Access Compliance Report

Public Rights-of-Way

(Curb Ramps)

Intersection ID: 30299	Main Street: DERRYFIELD_DR	Cross Street: MUMFORD_LN	Location: SE
ADA ID: BA344CA12DF0	Ramp Type: PerpDiag	Initial Pass/Fail: Pass	Overall Compliance: No
Severity Score: 15			
Codes/Mitigation Info/Possible Solution		Field Measurements/Component Compliance

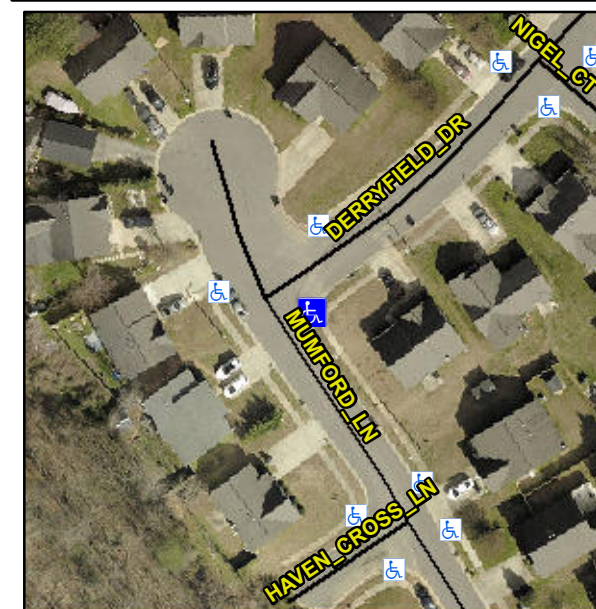
Not Found, R304.2.1, R304.2.2-Perp, R304.3.2-Para, R305.1.4, R305.2, R302.7.2, R304.5.4

Compliance	Description	Data	Compliance	Description	Data
N/A	Ramp Length (in)	48.0	Yes	Ramp Slope (%)	6.2
Yes	Ramp Width (in)	60.0	Yes	Ramp XSlope (%)	1.7
N/A	Flare Type LT	Sloped	N/A	Flare Type RT	N/A
N/A	Flare Slope LT (%)	1.1	N/A	Flare Slope RT (%)	1.4
N/A	Flare Traversable LT?	No	N/A	Flare Traversable RT?	No
No	Landing Length (in)	44.0	Yes	DWS Provided?	Yes
Yes	Landing Width (in)	60.0	Yes	DWS Contrast?	Yes
No	Landing Slope (%)	3.4	Yes	DWS Length (in)	25.5
Yes	Landing X Slope (%)	0.4	No	DWS Full Width?	No
N/A	Landing Curb? (Y/N)	No	No	DWS Offset (in)	2.5
N/A	Shared Landing?	No			
Yes	Gutter Ponding?	No	No	Gutter Slope (%)	5.5
No	Gutter Lip Ht (in)	0.5	Yes	Gutter X Slope (%)	1.2
N/A	Painted X Walk1?	No	N/A	Painted X Walk2?	No
	X Walk 1 Direction	To NE		X Walk 2 Direction	To SW
N/A	X Walk 1 Width (in)	N/A	N/A	X Walk 2 Width (in)	N/A
	X Walk 1 Slope (%)	0.9		X Walk 2 Slope (%)	3.6
	X Walk 1 X Slope (%)	1.8		X Walk 2 X Slope (%)	0.9

N/A	Ramp inside XWalk1?	N/A	N/A	Ramp inside XWalk2?	N/A
	Road Slope (%)	2.0	N/A	Clear Space?	Yes
	Road X Slope (%)	3.1	N/A	Clear Space to XWalk (in)	N/A
Yes	Any Obstructions?	No	Yes	Storm Grate/Utility Hazard?	No
	Obstruction Type			Storm Grate/Utility Type	
		N/A			N/A
			Yes	Surface Condition? (G/P)	Good

Remove & Replace Curb Ramp With Two New Directional Ramps or Equivalent. Remove & Replace Gutter.
